REQUEST FOR COUNCIL ACTION

SUBJECT: Request for Adjustment to Stormdrain Impact Fees

**RE: WELL INDUSTRIAL PARK NO. 2 LOT 12 REQUEST FOR ADJUSTMENT TO
STORM DRAIN IMPACT FEES**

FIG 1 - EXISTING AND PROPOSED STORM DRAIN SYSTEMS

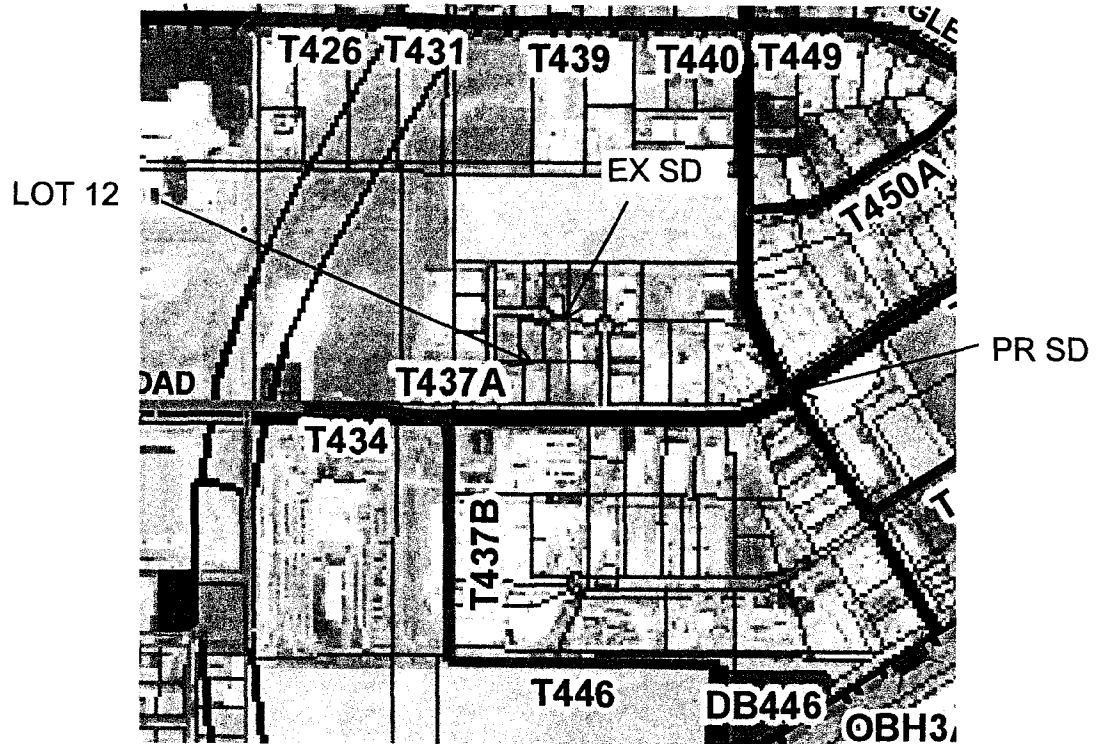
First, per West Jordan City requirements the lot is not allowed to connect to the existing drainage swale or storm drain pipe currently located in the subdivision. West Jordan City has a storm drain system in the area (see Figure 1) and an existing drainage swale that connects to the storm drain. West Jordan City will not allow a connection to the existing system.

Second, the future storm drain planned for the area does not extent to the subdivision and is not designed to convey storm water runoff from the area. The future Storm Drain Master Plan system only extends to 5600 West and not up to the subdivision. No storm drain pipe in the master plan can service Lot 12 therefore, Lot 12 will not be able to discharge into West Jordan's storm drain system.

Staff does not agree with this statement. In fact, staff has given the applicant three different options for addressing storm drainage for the site:

- 1) The lot could connect to a storm drain pipe, but it is not seen as an economical solution for the applicant because of the pipe’s distance from the lot.

- 2) There is a drainage swale that runs along the frontage of Lot 12. City staff could not verify the capacity of the swale and required the applicant to submit data on the ability of the swale to accept an additional volume of water. Years ago, when the Well Industrial Park No. 2 was designed and constructed, the swale was intended to carry stormwater runoff through the subdivision. In newer subdivisions, stormwater is transported in underground pipes. Lot 2 does not have adjacent or nearby underground pipes that would be found in newer subdivisions, and as stated in Mr. Haight’s letter there is no nearby master planned underground piping system to serve this Lot 12 in the future.

- 3) The third option was to design a stormwater retention system that holds all stormwater on-site allowing the water to percolate into the ground. After weighing the options, the applicant chose option three.
